ADDENDUM #2 DATE: 09.22.2022

PROJECT MANUAL FOR:	CP221951 UMPB Ground Floor Renovation
ADVERTISEMENT DATE:	08.29.2022
PREPARED FOR:	The Curators of the University of Missouri
CONSULTANTS:	CP221951 bc DESIGN GROUP 12101 110th Street, Suite 100 Overland Park, KS 66210 913.232.2123 x 809

PROJECT:	UPMB Ground Floor Renovations
PROJECT NO:	MUHC – CP221951, R&B - 1202.0011414.000
DATE:	September 22, 2022
BY:	Tori Gillespie
RE:	Addendum #2
DWG REF:	See below
SPEC REF:	See below
CC:	Central File
SPEC REF:	See below

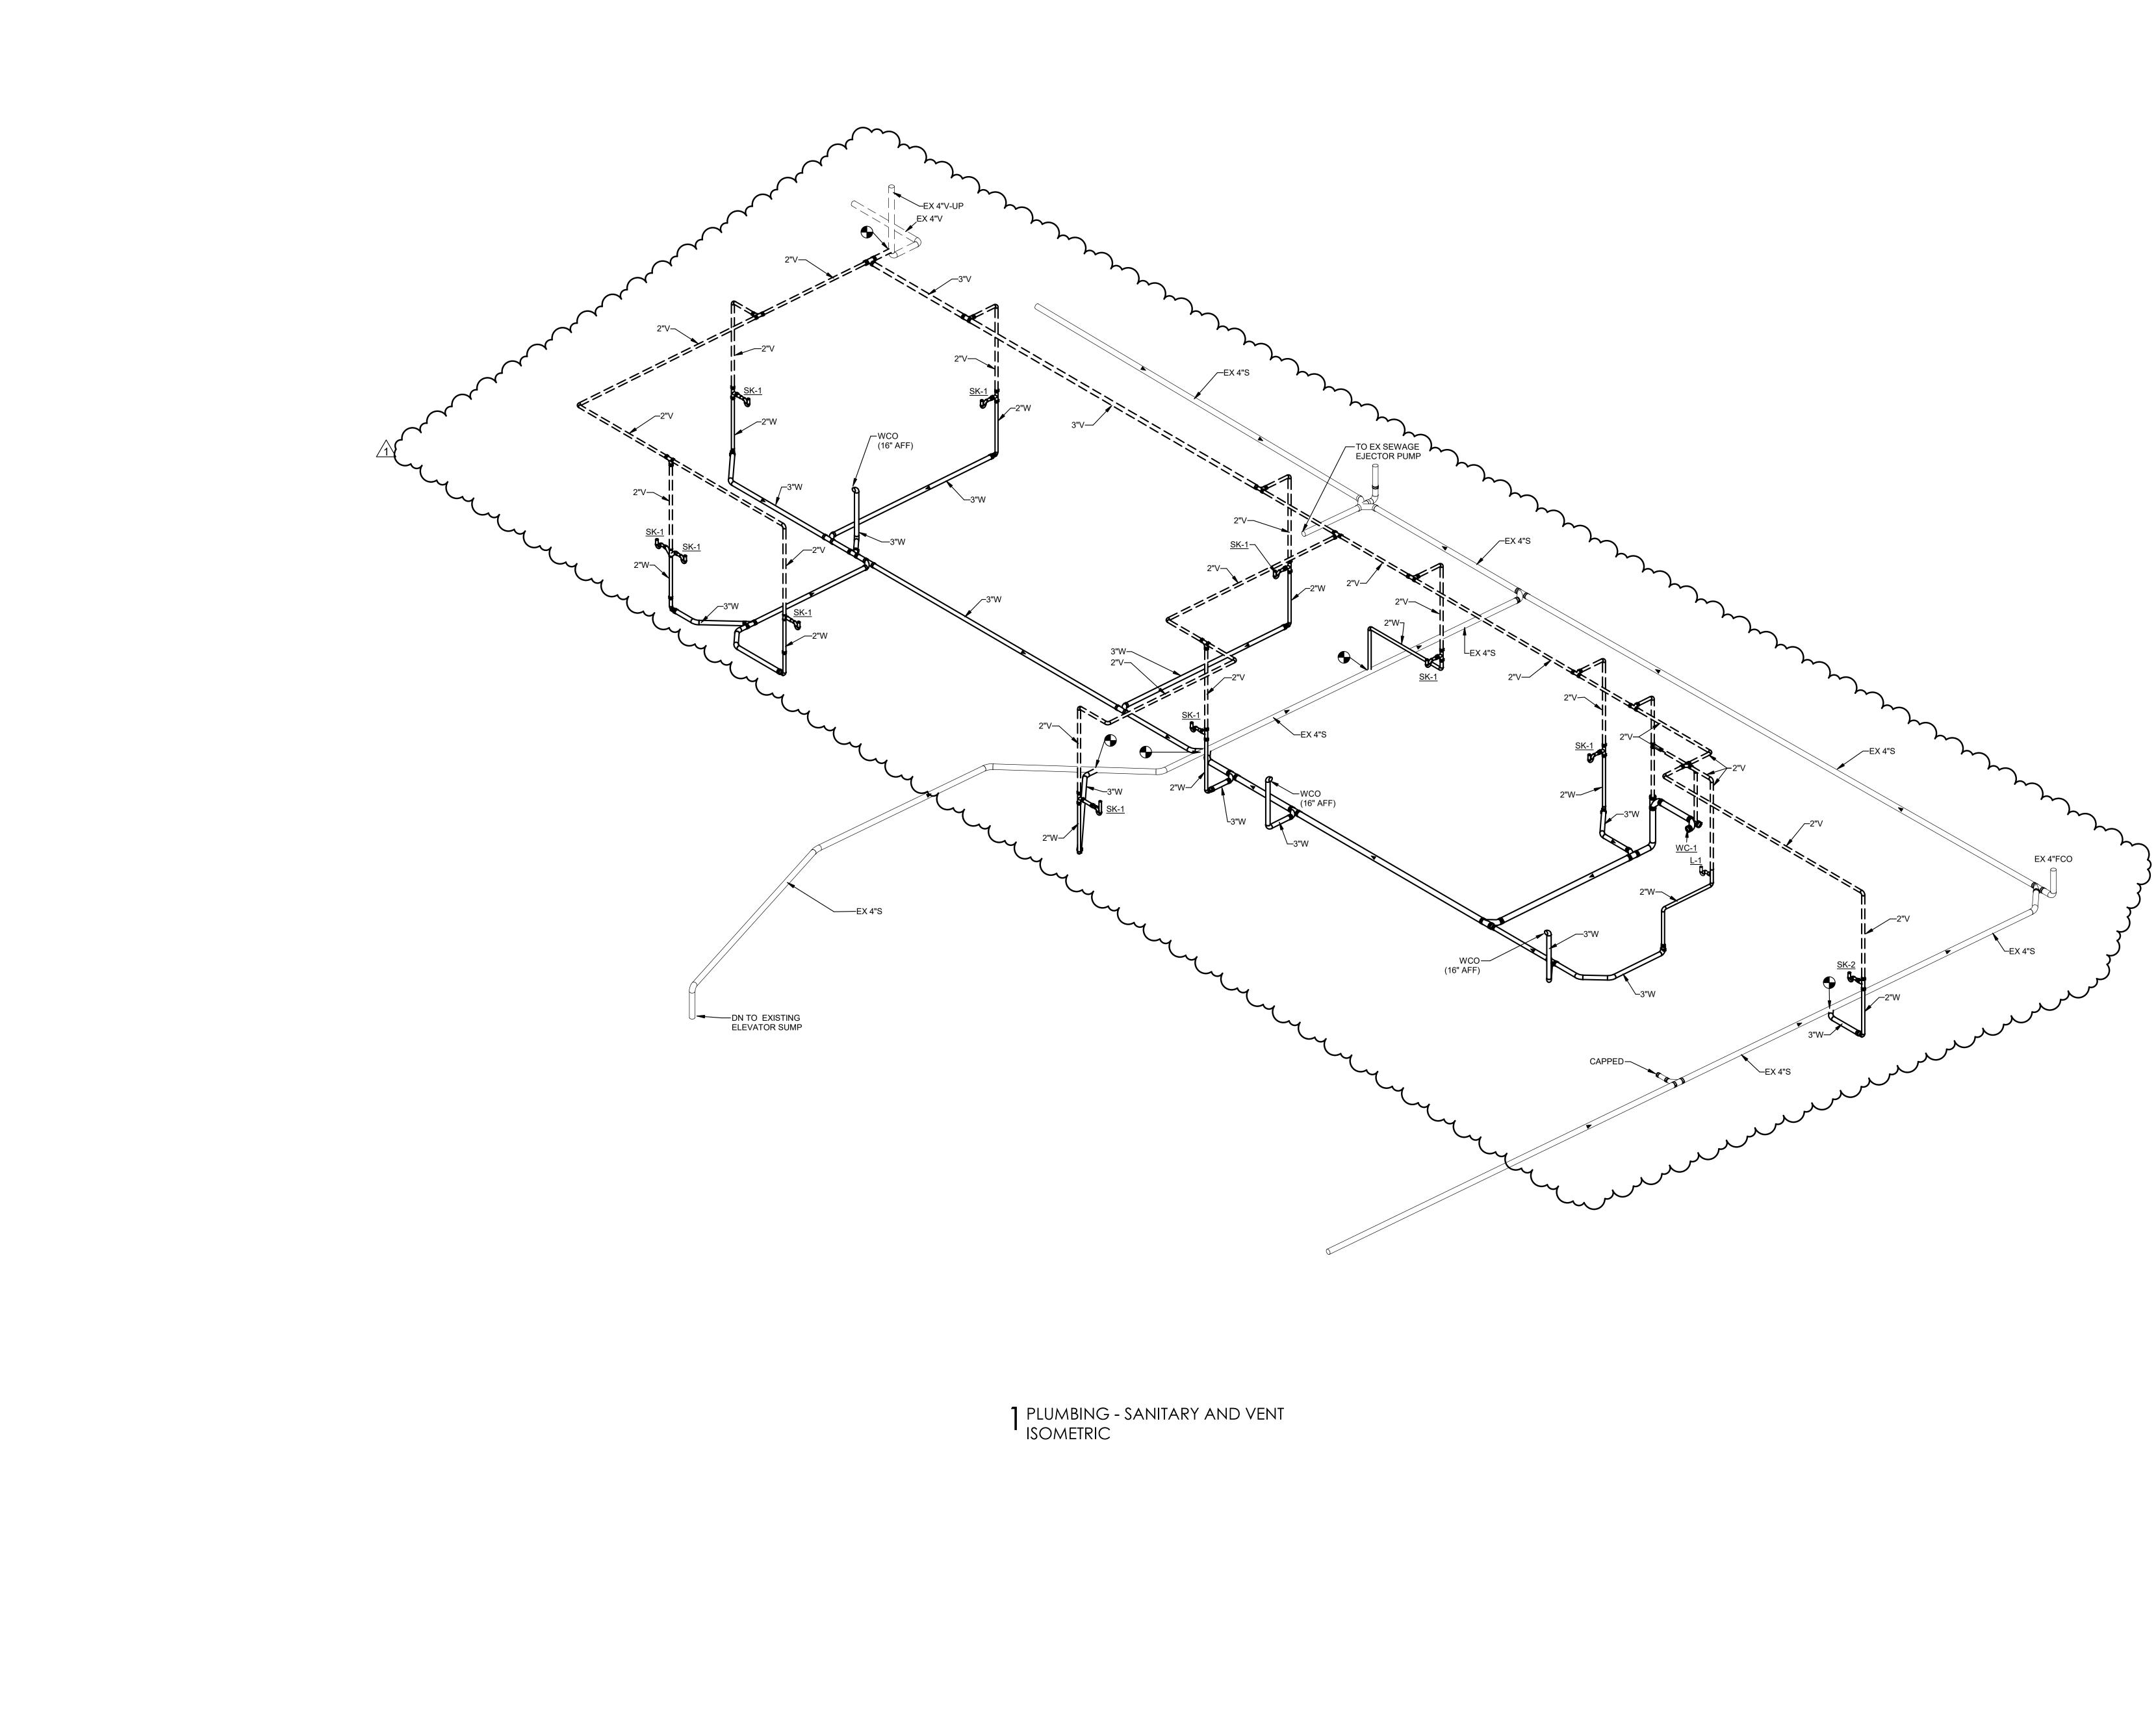
- 1. P100
 - a. REVISE routing of sanitary/waste piping & saw cutting to coordinate with structural footings.
 - b. ADD waste piping for new wall cleanout locations.
- 2. P101
 - a. REVISE sanitary & vent piping for water closet (model was changed to a wall hung unit).
 - b. ADD waste piping for new wall cleanout locations.
 - c. REMOVE two previous wall cleanout locations.
 - d. REVISE waste piping for a sink and lavatory to be routed in wall before dropping below slab to coordinate around structural footings.
- 3. P400
